RADFORD ARMY AMMUNITION PLANT, VIRGINIA

NRU Additional Characterization Sampling: Work Instructions

Re: Radford Army Ammunition Plant
New River Unit, Dublin, Va.
Draft revised *NRU Additional Characterization Sampling Work Instructions*
Review of the Army's 5/21/04 response to EPA's 4/21/04 comment letter

Response to USEPA Comments dated 21 April 2004
for
Draft NRU Additional Characterization Sampling Work Plan
Dated November 2003

EXHIBIT 2
BUILDING DEBRIS DISPOSAL TRENCH
PROPOSED SAMPLING

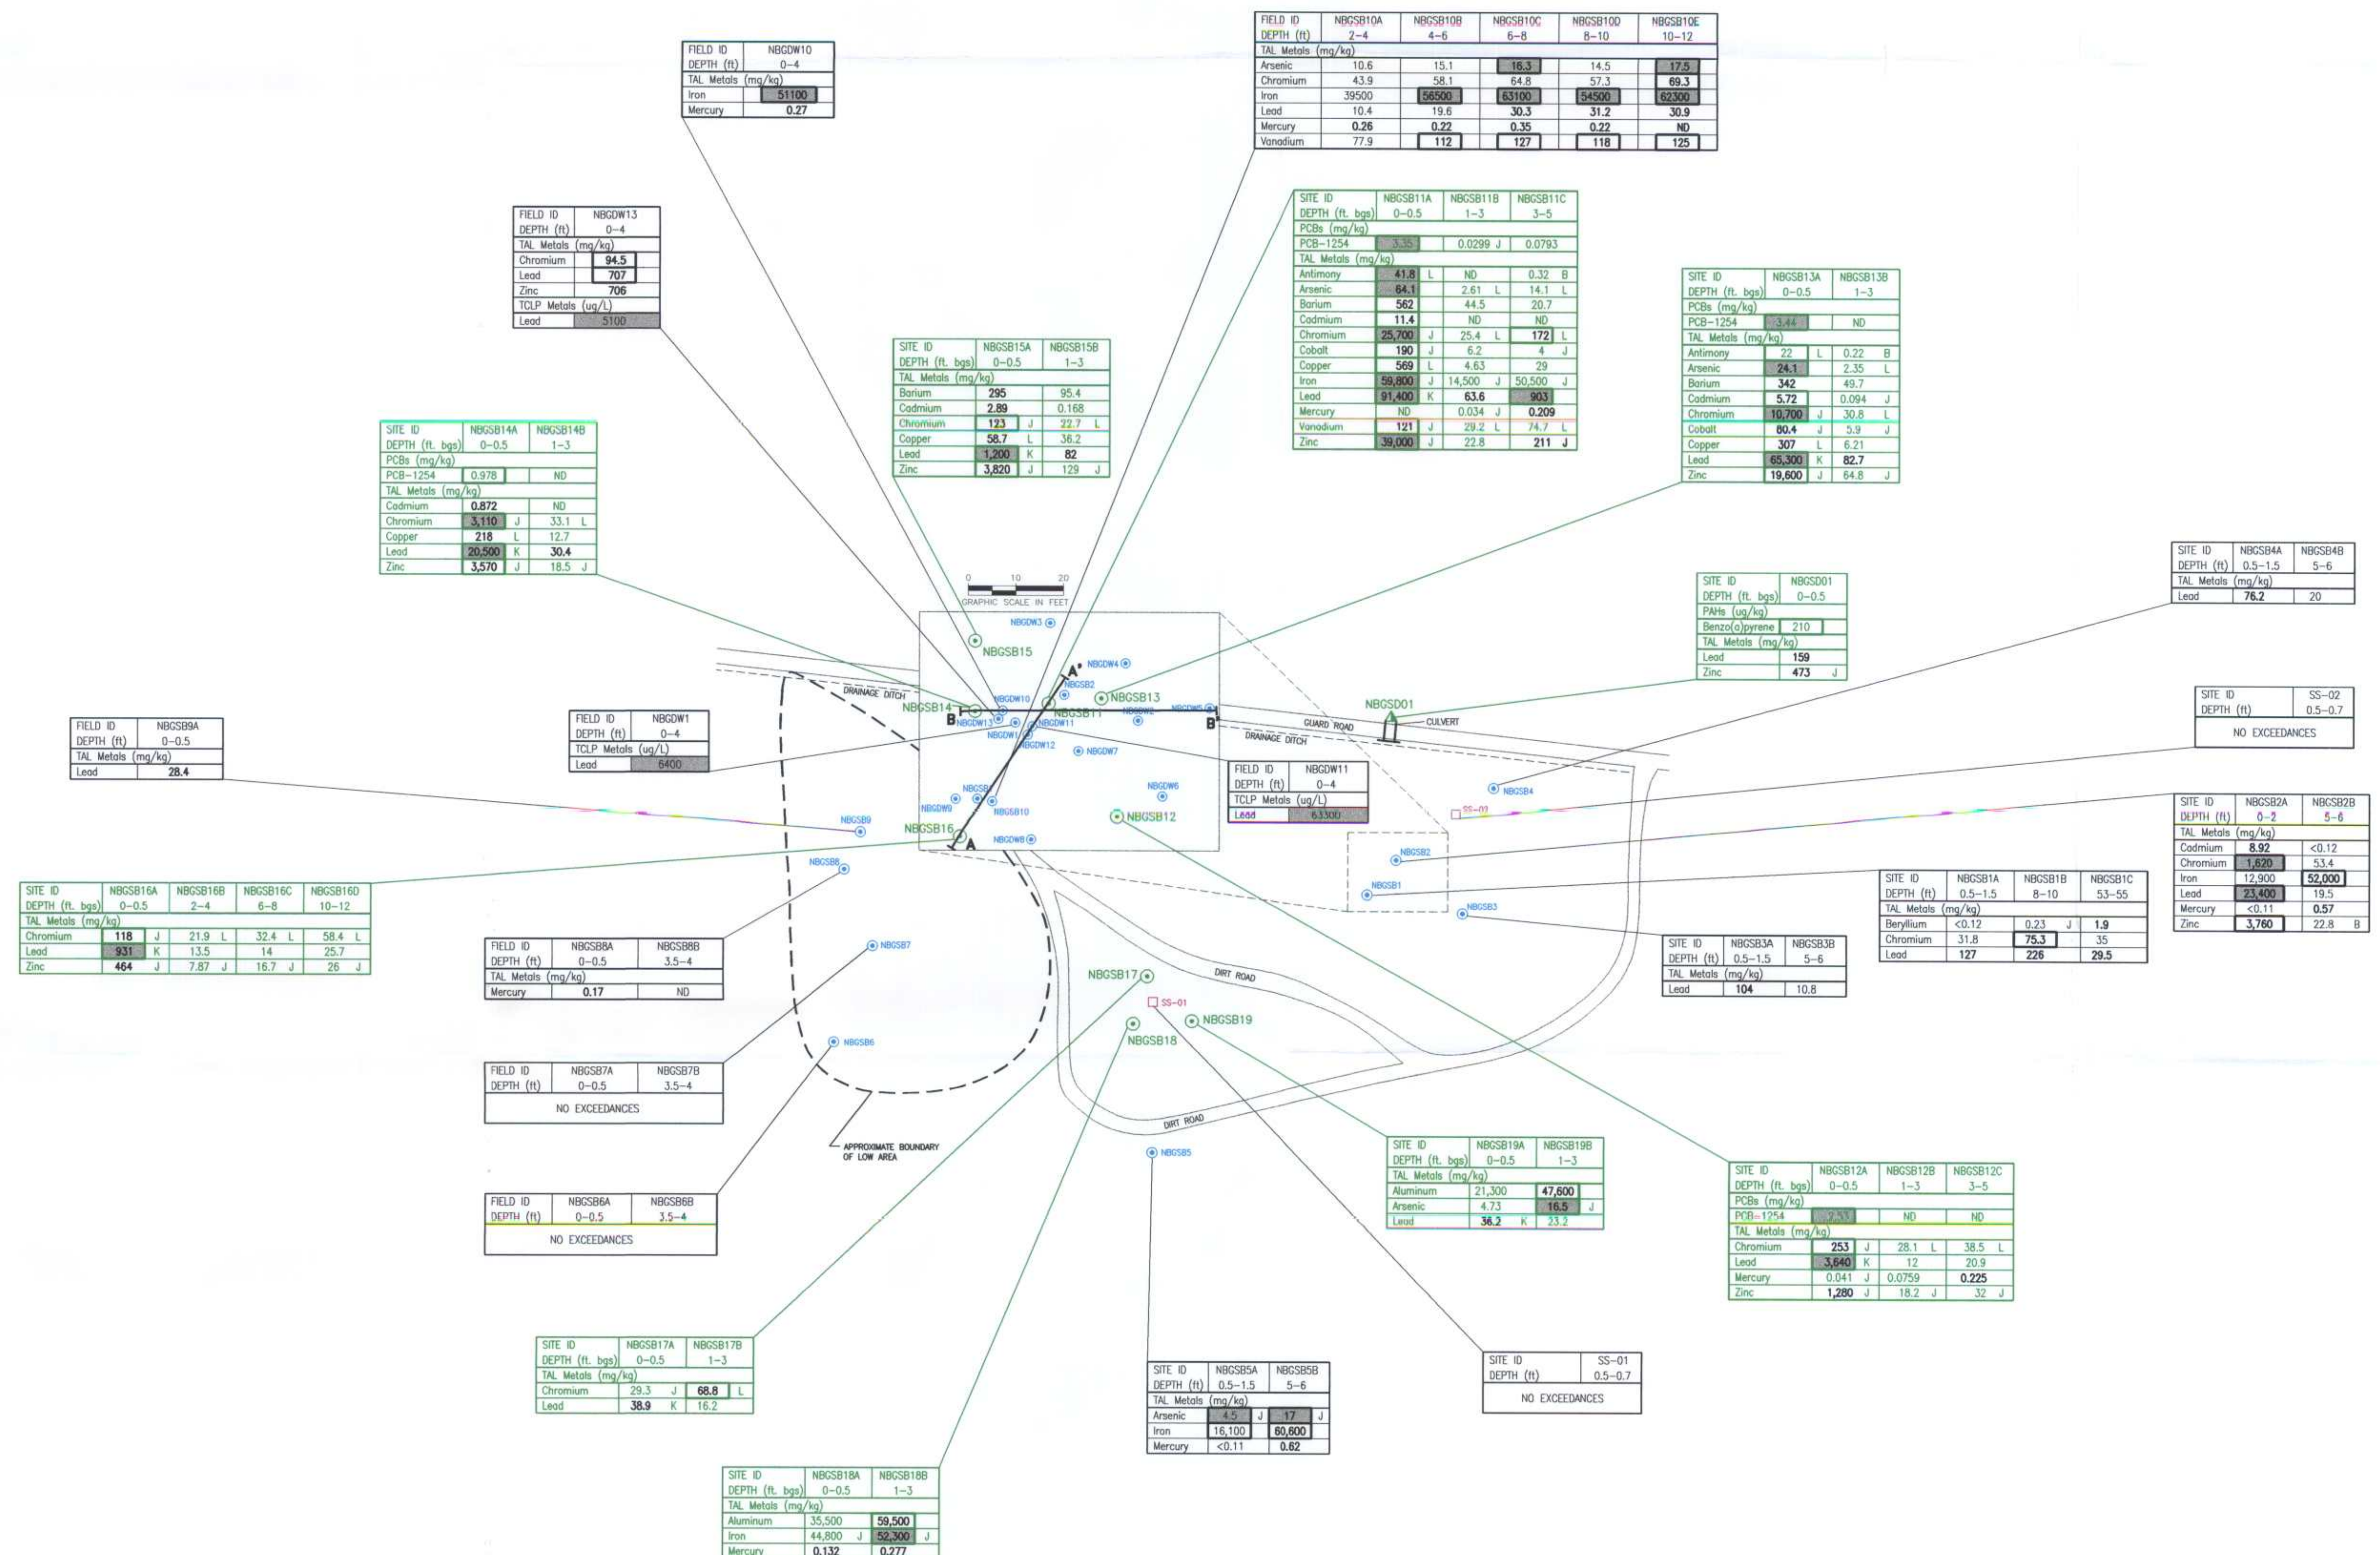
Sampling Locations: This Figure depicts the 24 proposed grid-sampling locations. Section 1.1.3.1 indicates that an initial 12 samples will be collected, and the remaining samples will be stepped out from the original locations, based upon the results. Please revise Figure 1-3 to differentiate the initial proposed 12 samples from the final 12 sample locations. Also, discuss why no additional sampling outside of the grid area (e.g., the rip rap area) is not proposed, as the results of the previous sampling indicate constituents that are present at concentrations exceeding various screening criteria including background values.

The legend for Figure 1-3 indicates that the values in the shaded cells exceed either the April 2003 EPA Region 3 Residential Risk-Based Concentrations (RBCs) for soil or the 1999 EPA

National Recommended Water Quality Criteria (NRWQC) (chronic) values. Please revise this figure to clearly indicate which values exceed which screening criteria or list these screening values on the figure. Also, it is not clear why the NRWQC values are being used as screening for water samples, since the RFAAP SSP requires use of the tap water RBCs for screening water samples and maximum contaminant levels (MCLs) for groundwater and surface water used as a source of drinking water. If the use of NRWQC is necessary for some reason, please use the most current version of *NRWQC human health criteria matrix calculation* (November 2002) and revise any conclusions drawn from this comparison as appropriate.

Page 1-8 & Figure 1-3: as illustrated in Figure 1-3, there is a distance of approximately 90 feet of the BDDT that will not be sampled. The last sample collected from the trench, DTSB45, recorded a benzo(a) pyrene level of 1300 ug/kg, which exceeds the industrial screening level. It would be beneficial to collect a sample in the 90 foot stretch of trench that has not been investigated. Rather than collected a sample from the outlying area, please add one surface soil sample between DTSB45 and the first proposed sample collection point.

In response to this comment and similar comments in Comments 11, 13, and 14, only the 12 initial samples will be presented on the figure. Samples have not been proposed for the rip-rap area because this area has been backfilled with clean fill and covered with geotextile membrane and rip-rap. No exposure pathways are present in this area.

RFAAP will use MCLs for screening (NRWQCs will be part of the SLERA).

Samples will be collected in the 90 foot stretch of trench that has not been investigated. The final number of samples will be determined by the results of initial samples. Figure 1-3 has been revised to show the sampling grid extending to the last soil sample collected in the trench (DTSB45). The figure has also been revised to present the locations of only the 12 initial samples. The text has been revised to clarify that samples will be collected in the trench area as guided by initial sample results.
